POP55 modification by K. Arai May 20, 2011

Title		Date Last Modified: 17-May-99	
LSC Photodiode		LIGO Laboratory California Institute of Technology Massachusetts Institute of Technology	
Size: B	DCC Number: D980454-01-C	PCB / SCH Revision: B / 1	Engineer: J. Suina D. Ouimette
File: S:\SYSTEMS\LSCPHOTOD-1\FINAL\SCHEMA-1\8045401A.SCH		Date: 12-Aug-1999	Time: 16:56:25
		Sheet 2 of 2

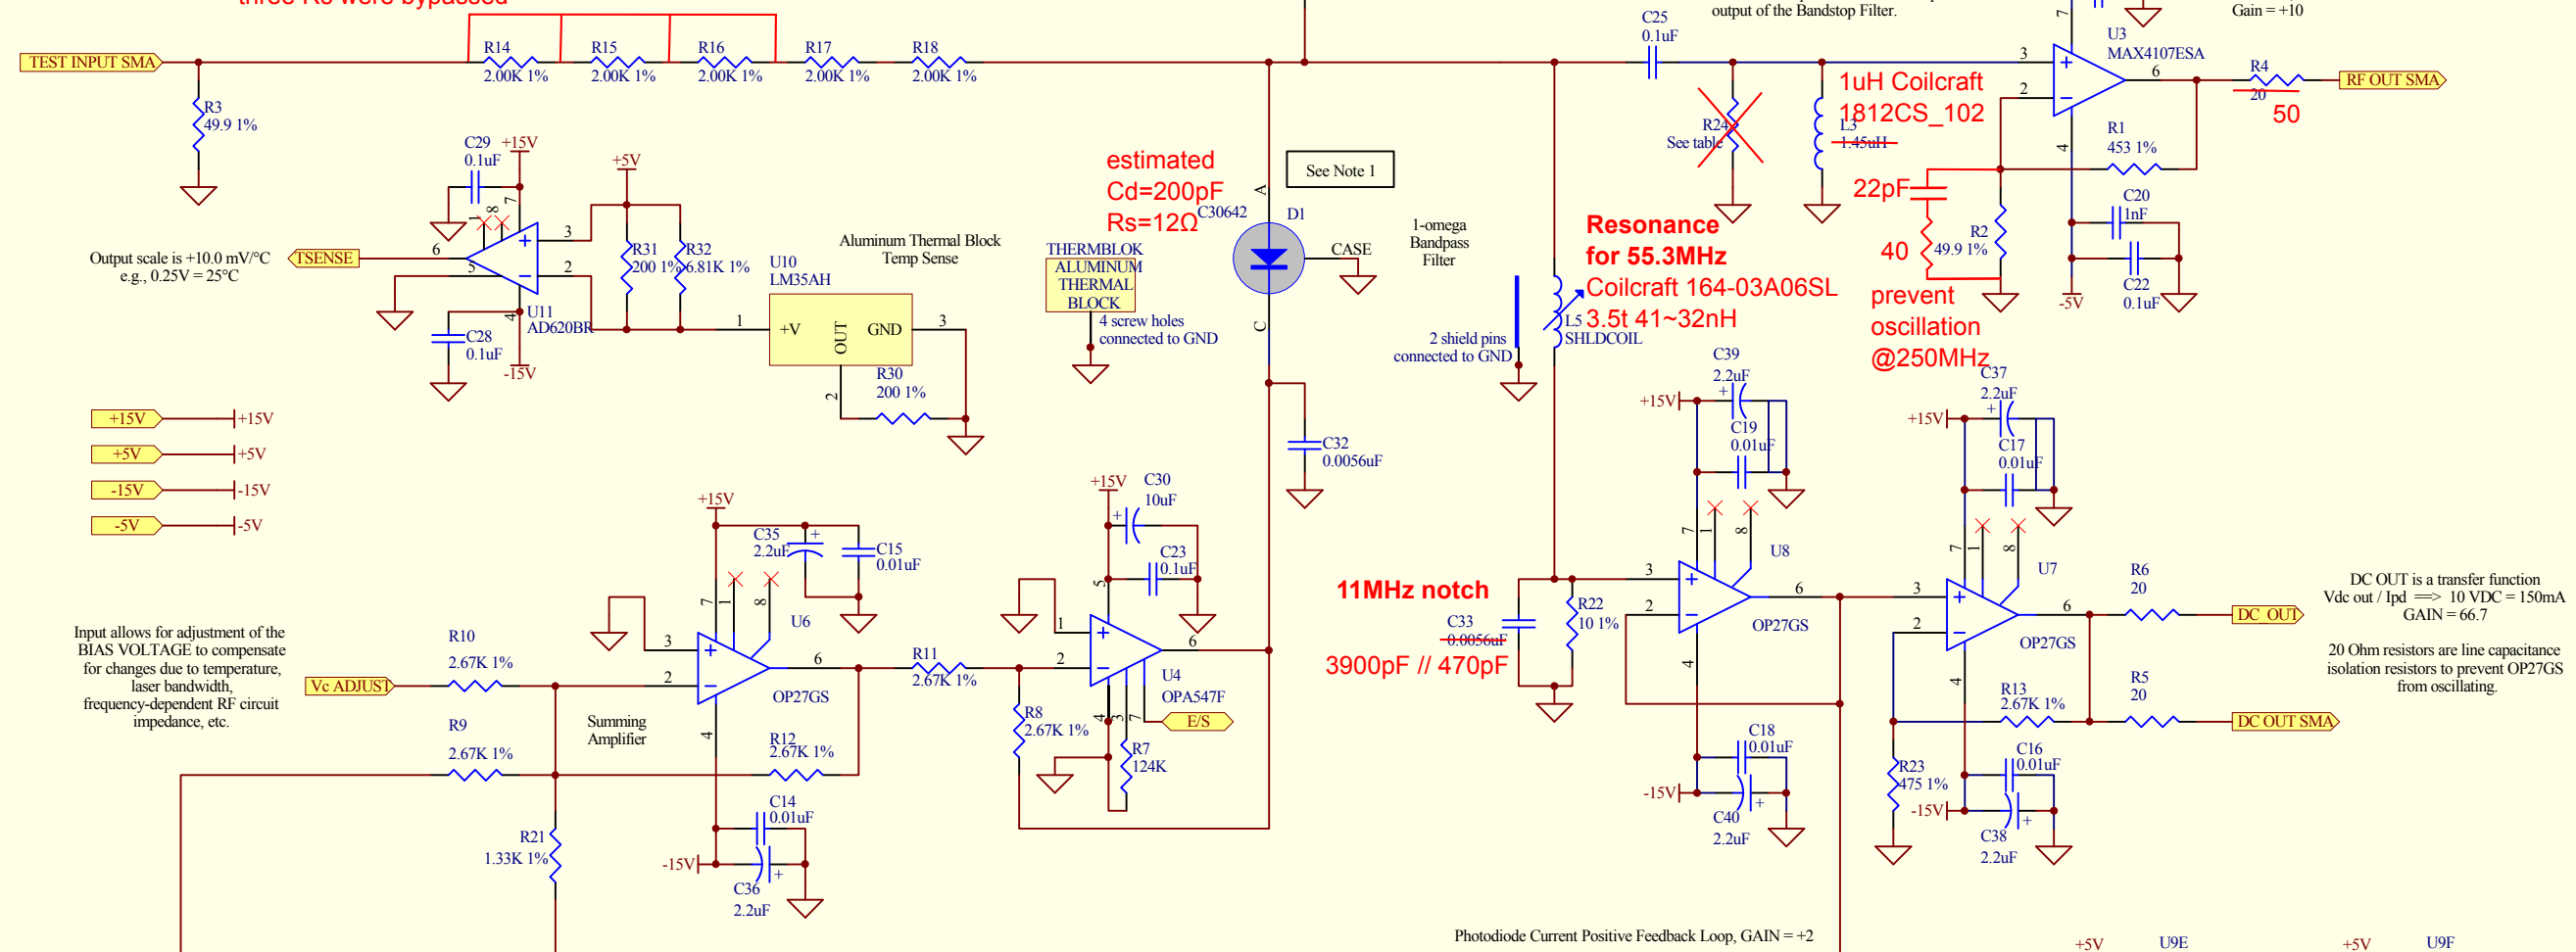
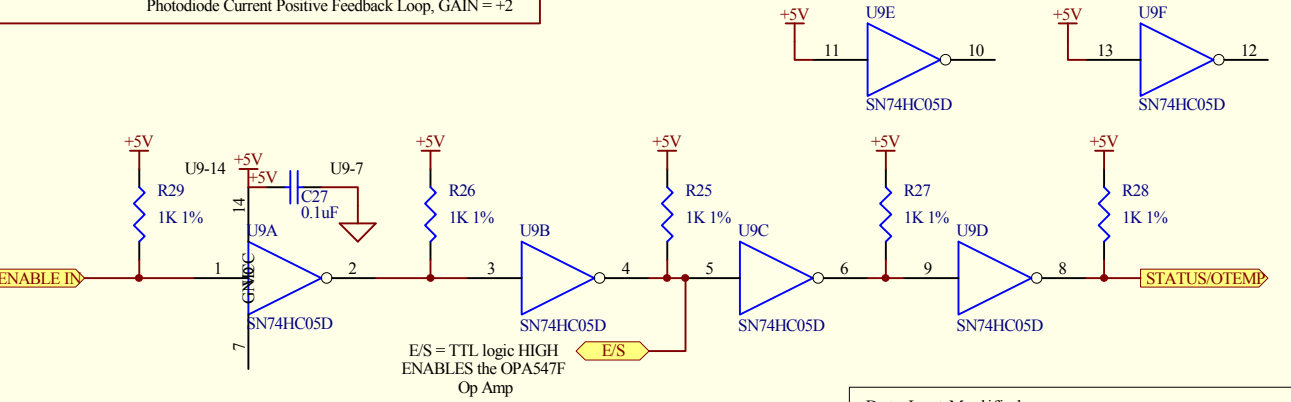
L&C of TEST INPUT produces a notch@~60MHz three Rs were bypassed

Multiple resistors divide out the distributed capacitance between TEST INPUT and RF CIRCUIT

100nH Coilcraft 1206CS_101
110MHz notch
3.5-50pF nominal 20.5pF

R24 may not be installed. In the previous revision 100pF has been installed on the R3 pad in order to achieve 81/162 MHz operation.
 At lower frequencies a resistor may be installed to impedance match the input and output of the Bandstop Filter.
